CITY OF CODY  
PLANNING, ZONING AND ADJUSTMENT BOARD  
TUESDAY, JANUARY 14, 2020  
CITY HALL COUNCIL CHAMBERS @ 12:00 NOON

<b>MEETING DATE:</b>	JANUARY 14, 2020	<b>TYPE OF ACTION NEEDED</b>	
<b>AGENDA ITEM:</b>		P&Z BOARD APPROVAL:	X
<b>SUBJECT:</b>	SITE PLAN REVIEW: SCHOOL DISTRICT TRANSPORTATION FACILITY. SPR 2019-21	RECOMMENDATION TO COUNCIL:	
<b>PREPARED BY:</b>	TODD STOWELL, CITY PLANNER	DISCUSSION ONLY:

<b>MEETING DATE:</b>	JANUARY 14, 2020	<b>TYPE OF ACTION NEEDED</b>	
<b>AGENDA ITEM:</b>		P&Z BOARD APPROVAL:	X
<b>SUBJECT:</b>	ARCHITECTURAL REVIEW, ENCLOSE PORCH AT 3202 BIG HORN AVENUE SPR 2019-24	RECOMMENDATION TO COUNCIL:	
<b>PREPARED BY:</b>	TODD STOWELL, CITY PLANNER	DISCUSSION ONLY:

<b>MEETING DATE:</b>	JANUARY 14, 2020	<b>TYPE OF ACTION NEEDED</b>	
<b>AGENDA ITEM:</b>		P&Z BOARD APPROVAL:	
<b>SUBJECT:</b>	MINOR SUBDIVISION OF LOTS 10 AND 12 OF THE ROCKY MTN. BUSINESS PARK. SUB 2019-12	RECOMMENDATION TO COUNCIL:	X
<b>PREPARED BY:</b>	TODD STOWELL, CITY PLANNER	DISCUSSION ONLY:

C1.1

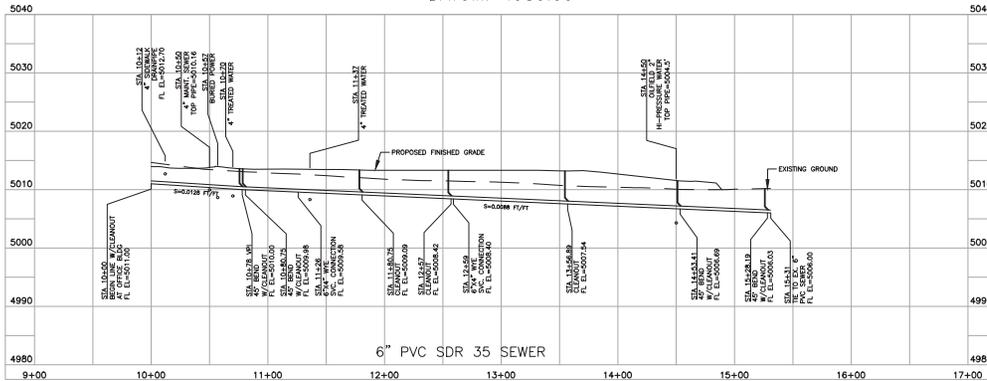
The building will utilize domestic water, power, gas, and sewer service. The general utility plans are shown on the site plan and plumbing plans (plumbing plans not included, but available), yet additional details are needed to show splitting the domestic water lines from the fire lines, and meter sizing. Public Works requests an updated plan with those details shown.

The utility plan does not identify pipe size to the water main. It needs to be sufficient to feed both 4" fire lines that come off of it—verify through the fire system design review.

1. All applicable city utility fees (water, sewer, electrical) are to be paid prior to building permit issuance—coordinate with Public Works.
2. Provide an updated civil site plan with more/corrected detail of how the driveways tie into the east road and Sheridan Avenue, and the water line details that are missing. Those components of the plan are subject to approval by Public Works.

3. Modify the utility plan to run the electric line under the high-pressure waste line.
4. Add a note to the landscaping plan (A1.0) to coordinate location of the trees near Sheridan avenue and the “gravel road” with the city, to ensure they are planted and remain outside of the utility easement and sight-distance triangles based on mature spread. The School District need not complete landscaping prior to occupancy of the building, but shall complete it by fall of 2021.

**ARCHITECTURAL SITE PLAN - BUILDING LOCATION**  
 1" = 40'-0"

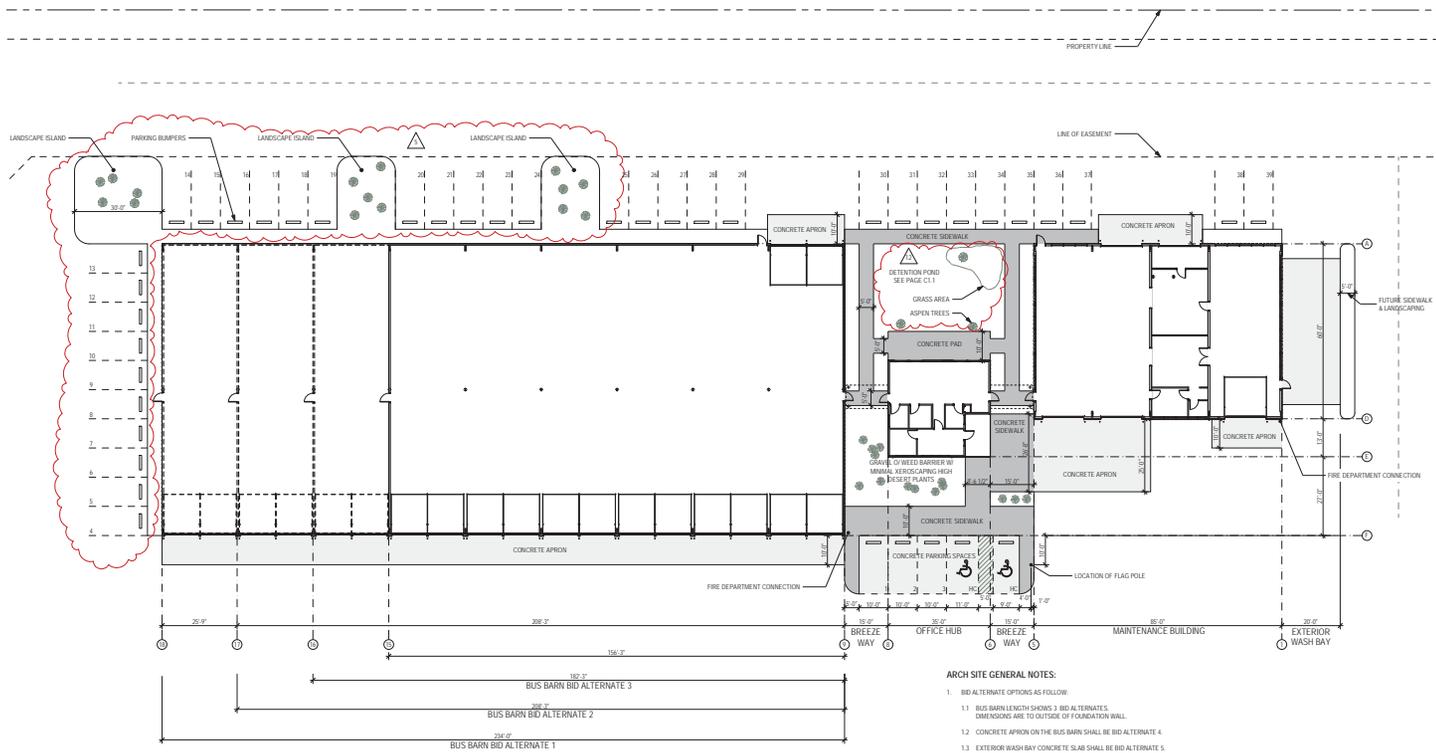
An updated landscaping plan has been provided—see attached. As was the case in the original plan, the area in front of the office building will include “minimal xeriscaping high desert plants”. The updated plan adds six fir trees at each of the vehicular entrances. Five fir trees and six aspen trees in a manicured grass area is added to the east of the buildings—which area also serves as the detention pond. A few aspen trees and a grass area are added to the detention pond area behind the office building. To break up the plainness of the back of the bus barn building, two or three landscape islands with shrubs/trees? have been added along the back of the building.

The tree locations are conceptual, and some will need to be shifted slightly, so that they are outside of the 10-foot utility easement along Sheridan Avenue and sight-distance triangles, based on their mature spread. City staff will work with the school district staff to ensure proper placement. For now, a note should be added to coordinate location of the trees near Sheridan avenue and the “gravel road” with the city.

SHEET #  
A1.0  
MAIN FLOOR

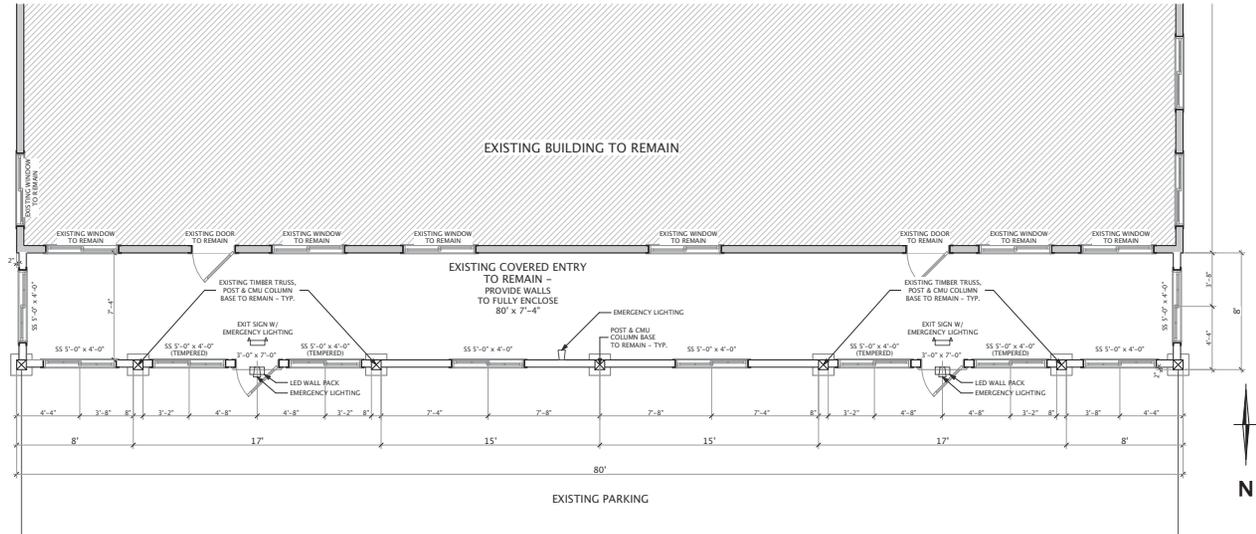
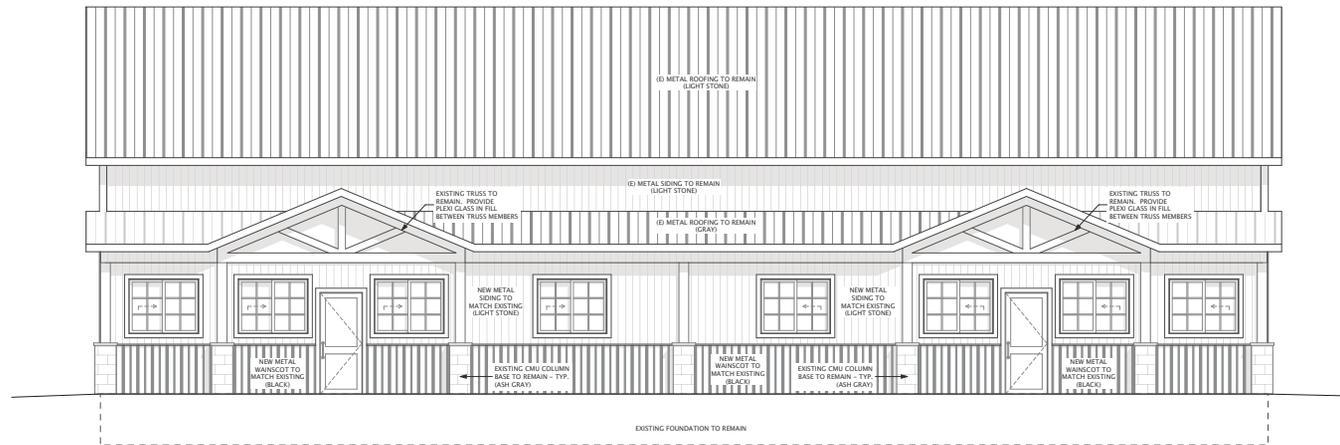
The current proposal would hide all of the existing masonry enhancement with the exception of the column bases, and visually replace it with black metal siding.

The use of black sheet metal for the proposed front wainscot is admittedly the cheap alternative. Staff would prefer if the applicant investigated a more aesthetically enhancing material or texture. It is anticipated that any additional expense that may involve would be more than reflected in the resulting value.

The proposal does not consider that the lighting under the existing canopy serves as parking lot lighting for the row of parking immediately in front of the building. The parking ordinance requires lighting of all parking areas used at night, which is the case here. Exterior lighting will need to be added to the project. Provided the lighting is full-cut off in design and modest in intensity, the Board can authorize staff to review and approve the fixtures in conjunction with the building permit.

- 1) Lighting of the parking spaces in front of the building occur with full cut-off fixtures of modest intensity, and authorize staff to verify in conjunction with the building permit.
- 2) The project must otherwise comply with applicable building, fire, and electrical codes.

**UTILITY PLAN**

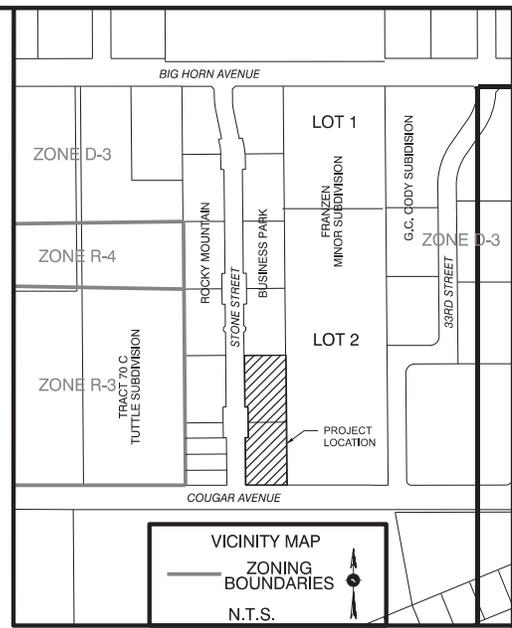
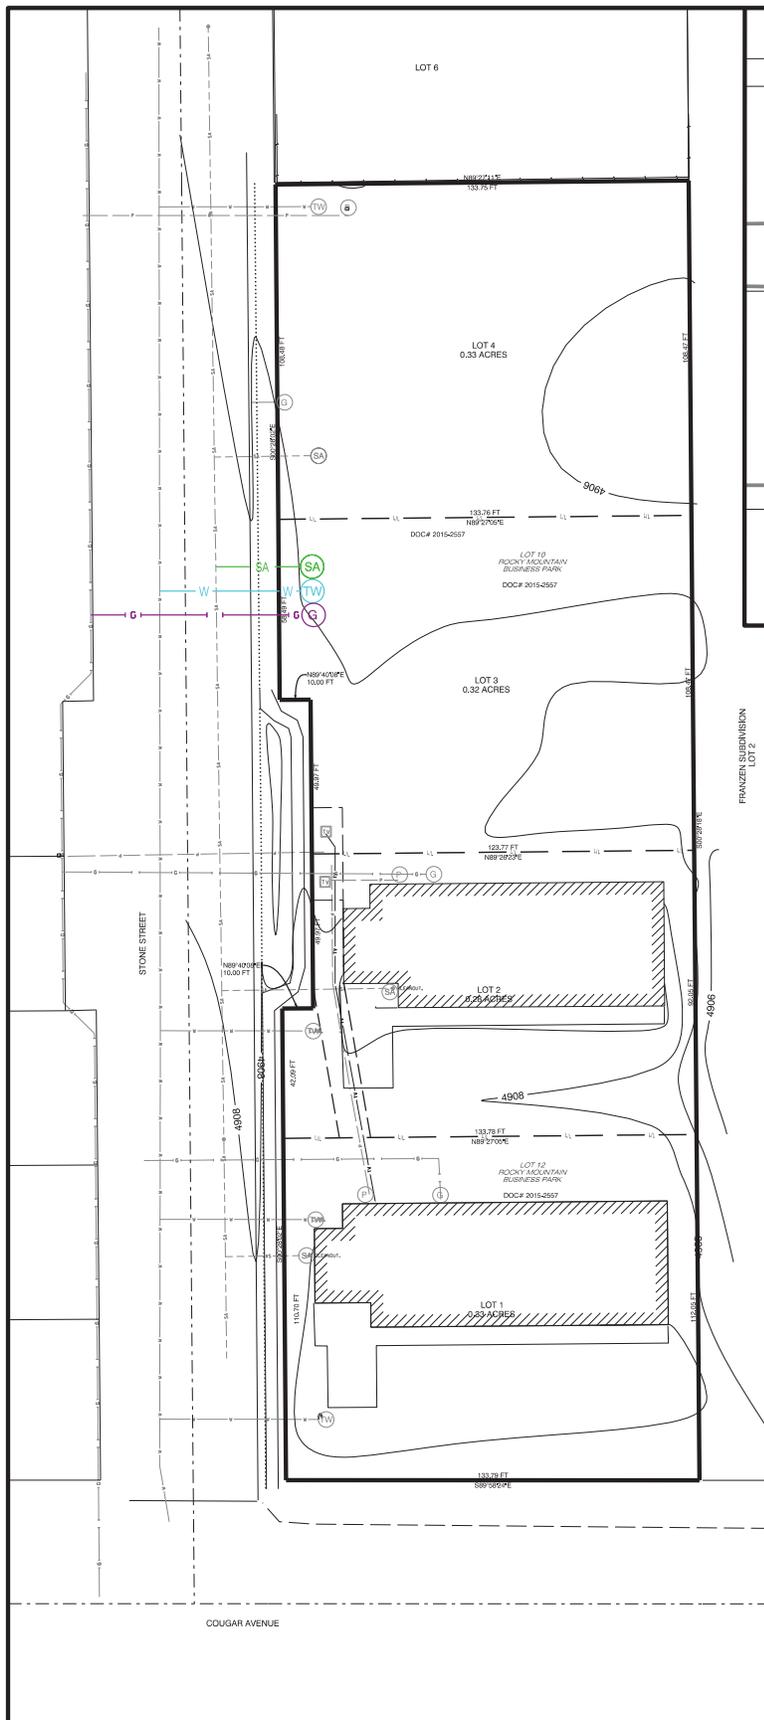
Comment: Stone Street is improved along the property frontage to city standards, except for sidewalk does not exist along proposed Lots 3 and 4. Sidewalk will need to be installed along the frontage of Lots 3 and 4 with this subdivision.

Comment: A water main is located in Stone Street. Water services exist for Lots 1, 2 and 4. Service for Lot 3 is proposed. Although not clearly noted, it appears that a single trench will be used for both the water and sewer service to Lot 3. If the water line is in the same trench and less than 12 inches above any sewer pipe, it must be sleeved, per plumbing code. Both the water and sewer service installations will need to be inspected by the City.

1. Provide a utility easement and plan for extension of power and telecommunications to Lots 3 and 4, for review and approval by Public Works. Note the easement on the preliminary plat, and note the plan on the utility plan drawing.

2. Note installation of sidewalk on Lots 3 and 4 as a subdivision improvement on the preliminary plat.
3. Make the corrections to the preliminary plat and utility plan noted by staff (typos, missing line information).

**C2.0**  
 SHEET 2 OF 2

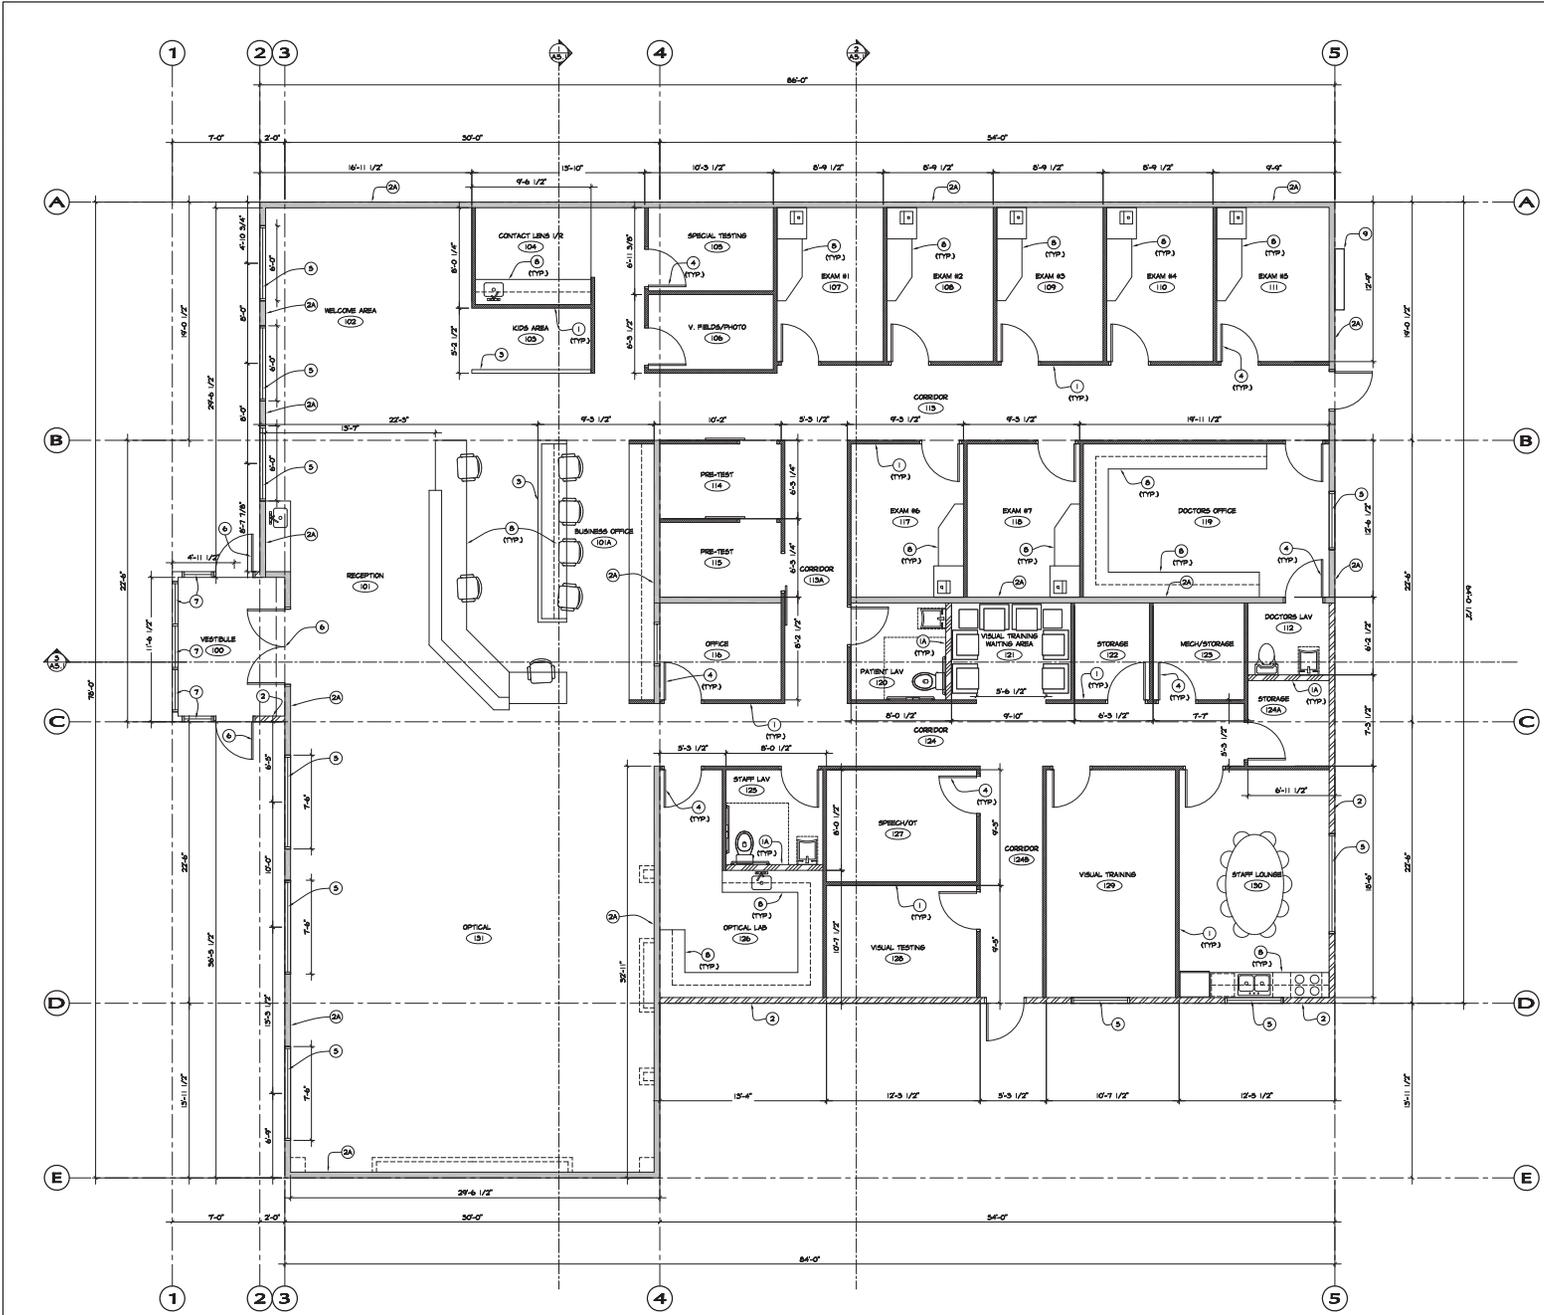
As can be clearly seen on Sheet C2.0, the site plan calls for paving everything between the curb and gutter (or sidewalk) and the property line. That area is outside of the property boundaries and in City right-of-way. All private improvements in City right-of-way first require authorization from City council through the encroachment license process. We are planning to present the proposal to City council at their next meeting, if possible. The Planning and Zoning Board cannot authorize the actual encroachment, but can review the request through the site plan process.
